# Agenda Item #: 1 - HOLDOVER

## SUB-002638-2023

Harris Subdivision

- Subdivision approval to create three (3) legal lots of record from one (1) legal lot of record.

# DETAIL SITE PLAN

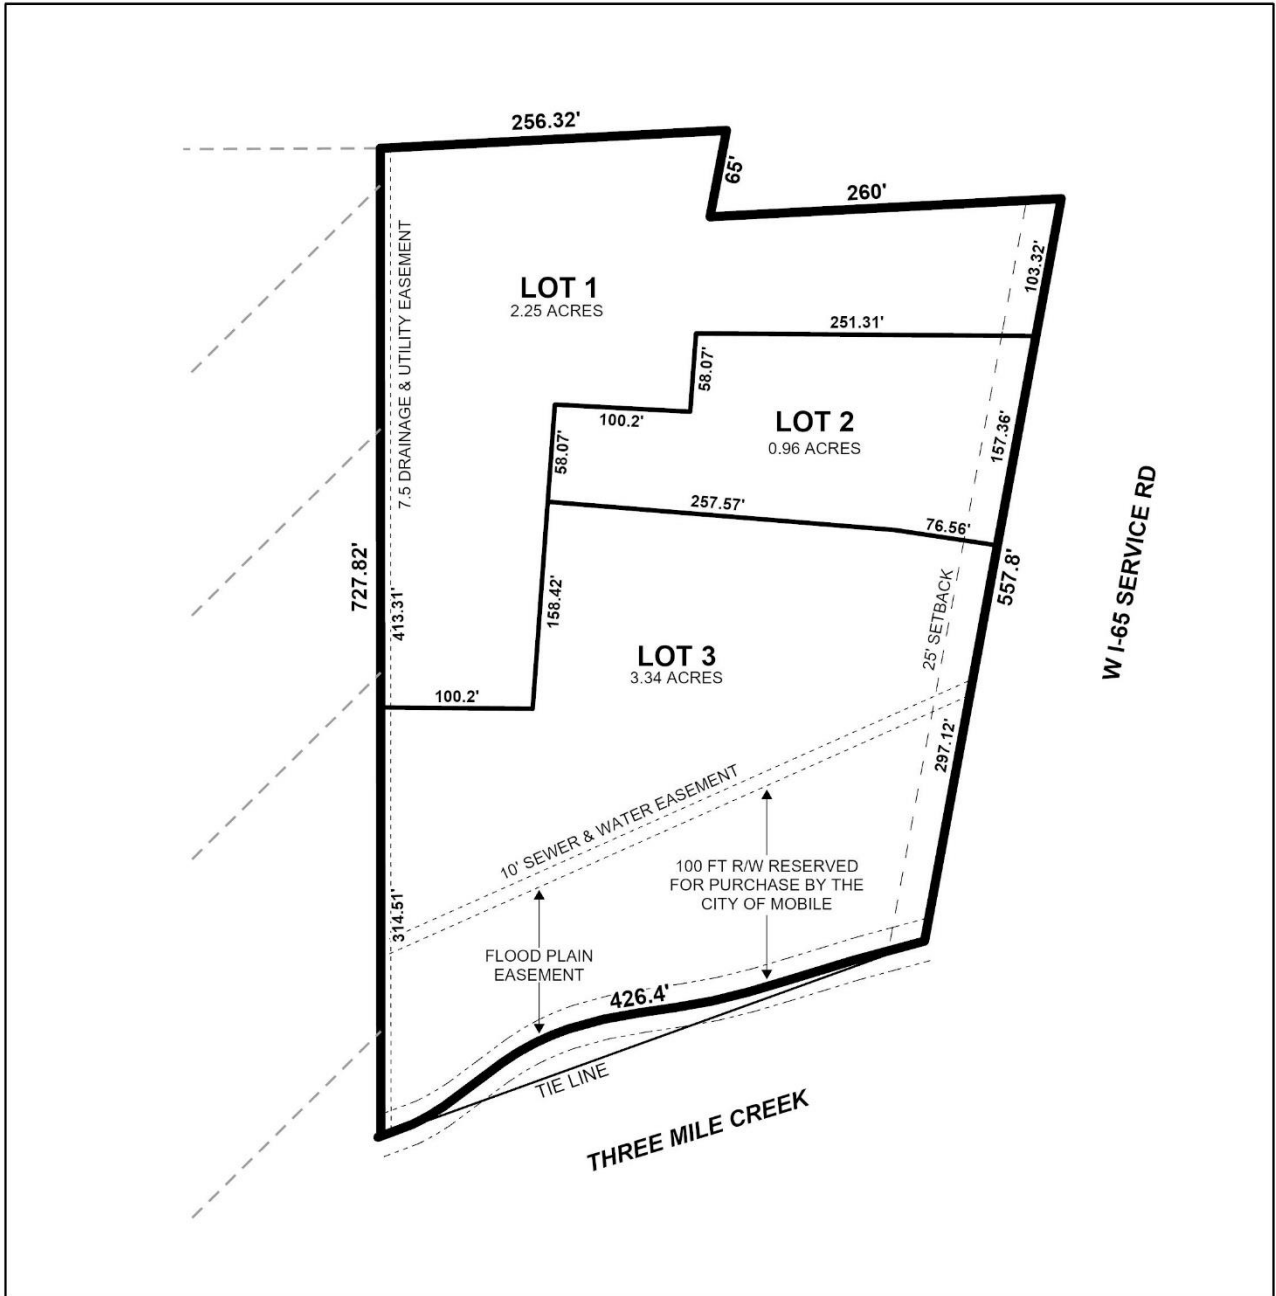
- B. Check the TOTAL AREA listed and the SMALLEST LOT listed. The numbers shown for each LOT don't add up correctly.
- C. Label the rectangular shape shown at the NE corner of LOT 3.

- D. National Wetlands Inventory (NWI) mapping, as shown on City of Mobile GIS information, indicates that there is potential for wetlands within the property or properties shown on this plat. Show and label the delineated wetlands, or provide a note stating that the wetlands shown on this plat are scaled from the NWI data and have not been delineated.

- E. Provide a note that a 25' riparian buffer may be required, during development, along the edge of anything considered by ADEM to be a water of the state.

- F. Show and label all flood zones. It appears that LOT 3 contains a bit of both AE and X(S) flood zones.

- G. Show and label the MFFE (Minimum Finished Floor Elevation) on each lot that contains an A, AE, or X (shaded) flood zone designation. BFE = 40.
- H. Add a note to the SUBDIVISION PLAT stating that as shown on the 1984 aerial photo (FLIGHT 24 - #72) LOTS 1, 2 and 3 will receive historical credit of existing (1984) impervious area towards stormwater detention requirement per Mobile City Code, Chapter 17, Storm Water Management and Flood Control) as follows: LOT 1 – 22,000 sf, LOT 2 – 30,000 sf AND lot 3 – 2,000 sf.
- I. Add a note that a Land Disturbance permit will be required for any land disturbing activity in accordance with Mobile City Code, Chapter 17, Storm Water Management and Flood Control); the City of Mobile, Alabama Flood Plain Management Plan (1984); and, the Rules For Erosion and Sedimentation Control and Storm Water Runoff Control.

The site has frontage on West I-65 Service Road North, an ALDOT-maintained street that services Interstate 65 and requires a 300-foot right-of-way. No right-of-way is depicted along the I-65 Service Road North at this location. While GIS maps indicate there is adequate right-of-way, the plat should be revised to depict that there is sufficient right-of-way along West I-65 Service Road North.

The depth of Lot 1 is greater than 3.5 times its width, which is discouraged by Section 6.C.3 of the Subdivision Regulations. However, such a lot design does not appear to be uncommon within the vicinity of the subject site, with the Planning Commission having approved several of them. As such, a waiver of Section 6.C.3 may be appropriate.

The preliminary plat illustrates multiple easements on the site. These easements should be retained on the Final Plat, if approved, with a note stating that no structure shall be constructed in any easement without permission of the easement holder.
